## RESPONSE TO REQUEST FOR ADDITIONAL INFORMATION

### APR1400 Design Certification

Docket No. 52-046

**RAI No.:** 405-8497  
**SRP Section:** 08.02 – Offsite Power System  
**Application Section:** 08.02  
**Date of RAI Issue:** 02/11/2016

[Figure] Overall differential scheme of MT and UAT in the APR1400

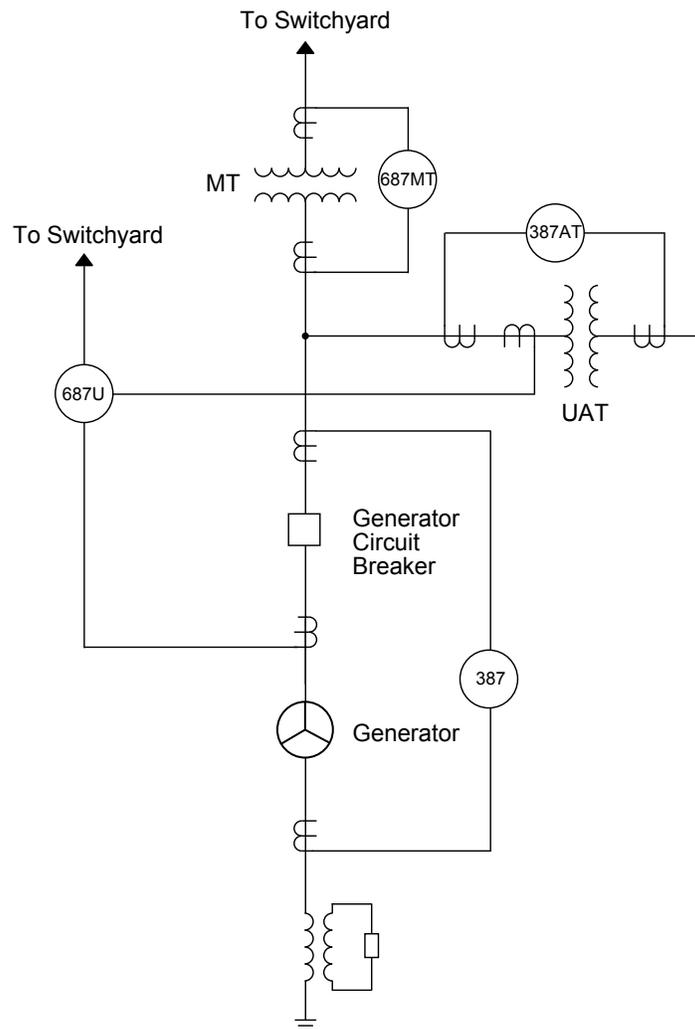
Furthermore, IEEE Std. 666-1991, Section 7.4.2, “Transformer Protection” states that “when the unit service transformer and generator step-up power transformers are connected to the generator terminals, an overall unit differential relay is often provided for backup protection of the equipment. This relay zone includes the neutral side of the generator and the high-voltage side of the unit service and generator step-up and power transformers. Frequently, this zone is extended to include the generator high-voltage circuit breaker(s). A fault occurring anywhere in this zone requires immediate shutdown of the unit.” The applicant stated that device number 87U, the unit overall differential relay, is only provided for the main transformer and not in the list of UAT protective relays. As stated above, IEEE Std. 666-1991 recommends that the relay zone include the high voltage side of the unit service transformer (in the APR1400 design this is defined as Unit Aux Transformer or UAT). Furthermore, DCD Tier 2 Section 8.1.3.3 states that the electric power system is designed to meet industry standards and lists IEEE Std. 242-2001, “IEEE Recommended Practice for Protection and Coordination of Commercial and Industrial Power Systems.” IEEE Std. 242-2001 discusses overall differential backup protection in Section 12.5.3.2.3, such that the overall differential scheme has the capability to detect severe faults. Please discuss why the unit overall differential relay is also not included for the UAT or provide an alternate means of providing generator overall differential protection.

The protection zone of the unit overall differential relay (687U) in the APR1400 encompasses the high voltage side of UAT as shown in the figure below. This is consistent with the recommendations of IEEE Std. 666-1991.

In order to ensure proper protection of the UAT during a severe fault, the UAT differential protection relay (387AT) includes an unrestrained instantaneous differential overcurrent function that is set above the maximum expected magnetizing inrush current value (e.g., three times rated current), but below the current value that might result in CT ac saturation (e.g., 20 times rated current). Moreover, the overcurrent relay (350/351) is provided for the UAT back-up protection.

Therefore, extension of the unit overall differential protection (687U) zone to the low voltage side of UAT is not necessary.
